ARL-SYS-TM-75

Systems Technical Memorandum 75

**PROPOSED MODIFICATIONS FOR THE RAAF
AIRTRAINER CT-4A COCKPIT**

FIG. 2 LEFT-SIDE EXPERIMENTAL SEAT ADJUSTED REARWARDS
ON THE INCLINED TRACKS

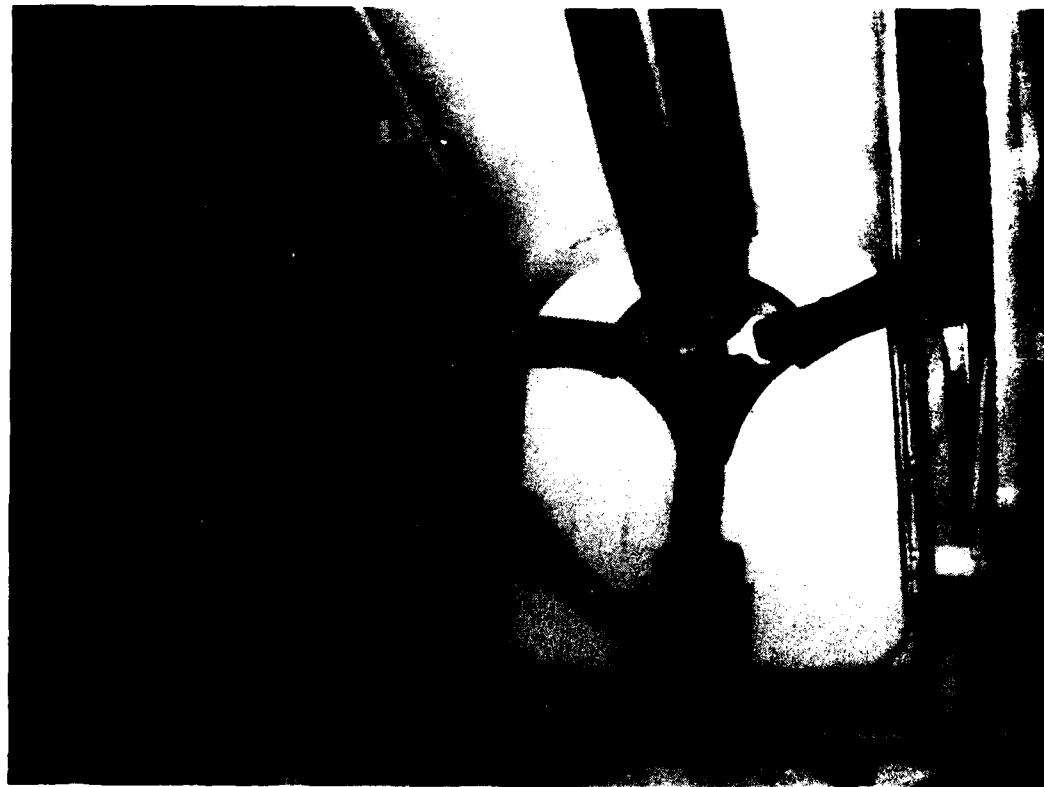
The seat should be supported by a rail on each side (see Figures 1, 2 and 3). The space below the seat should be filled with a structure designed to crush at a uniform rate under survivable crash loading in order to obtain full advantage of the available stroke. The front edge of the seat should have a cut-out approximately 30 mm longitudinally and 120 mm laterally to allow clearance for the control column and harness crotch strap in accordance with ASCC Standard 61/2.

FIG. 4 SIDE-BY-SIDE FUEL GAUGES

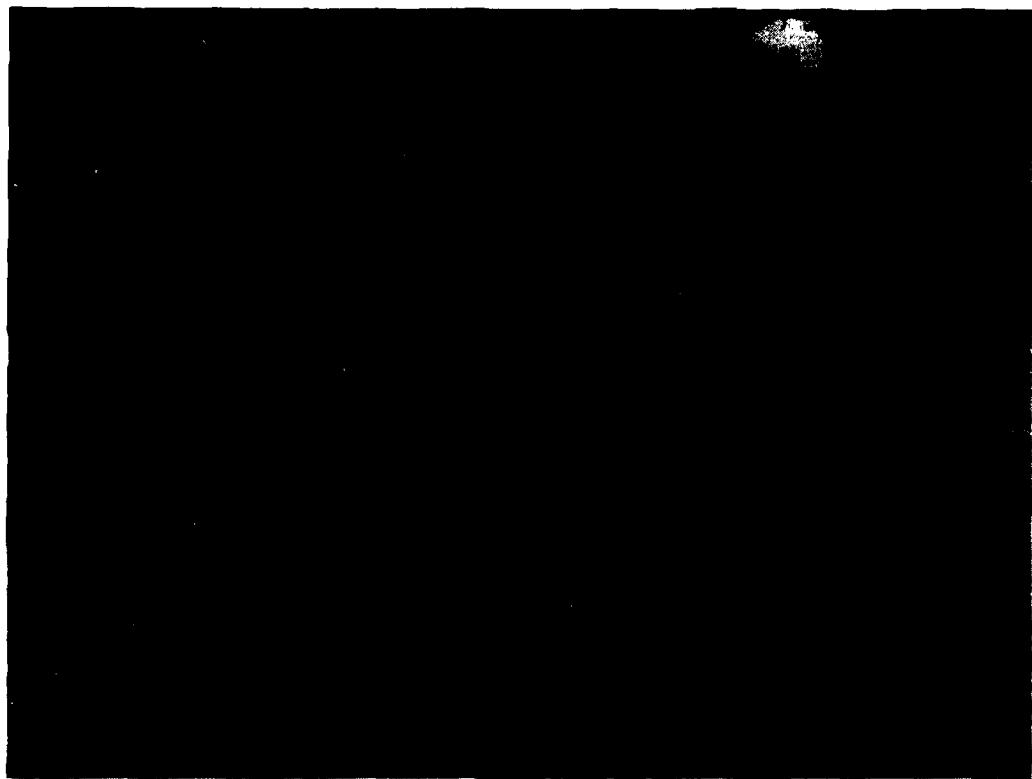
The fuel gauge should be replaced by a two-dial arrangement (see Figure 4) to display the contents of both tanks at all times. A single instrument case with adjacent scales no smaller than 25 mm diameter would be satisfactory.

FIG. 5 MODIFIED LEFT-SIDE THROTTLE QUADRANT
AND FLAP CONTROL

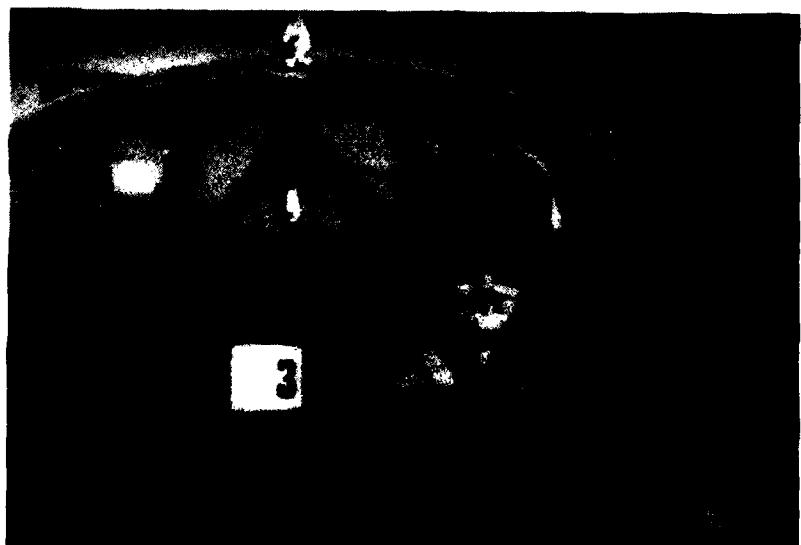
The existing left-side engine controls and flap selector should be replaced by a less bulky arrangement with the push-rods in a fairing outside the airframe (see Figure 5). The revised system should have the control levers closer together both at the handgrips and on their axis of rotation. A smaller friction-adjustment lever should be used and the revised system should protrude no further than 40 mm inboard from the inner fuselage skin. A guarded flap selector for the left pilot should be located just aft of the new quadrant partly in a recess in the fuselage skin.

This modification provides some much-needed knee room for the left pilot. Other ARL cockpit proposals (notably for the seat and pedals) would not be practical with the existing quadrant and internal push-rods. It seems likely that the drag associated with the small fairing would have a very small effect on climb and cruise performance, and this should be tolerated because of the major improvements gained in cockpit safety and comfort.

FIG. 6 EXPERIMENTAL PEDAL ASSEMBLY WITHOUT BRAKE MASTER CYLINDERS

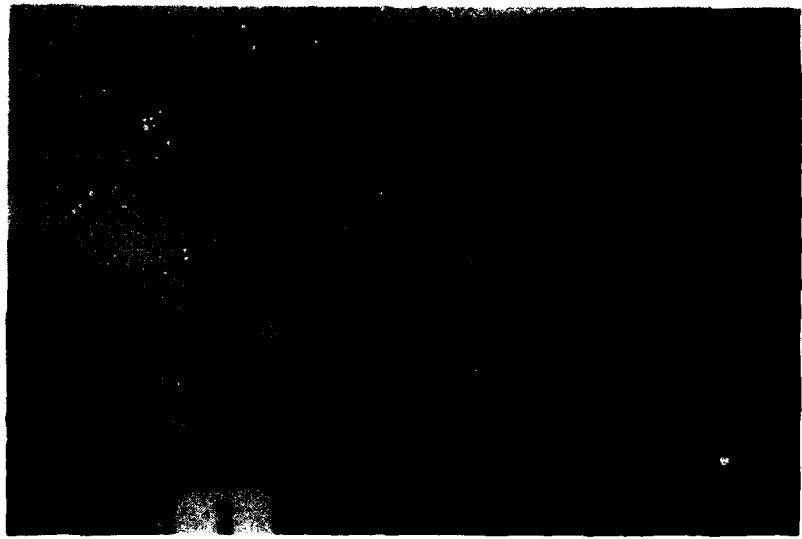
The pedals should be placed 35 mm forwards of their existing CT-4A position (cf. 50 mm for the NZAIL modification). They should retain their present adjustment range and orientation. This modification should not be implemented in the absence of seat adjustment as described in Section 5.1.2 above.
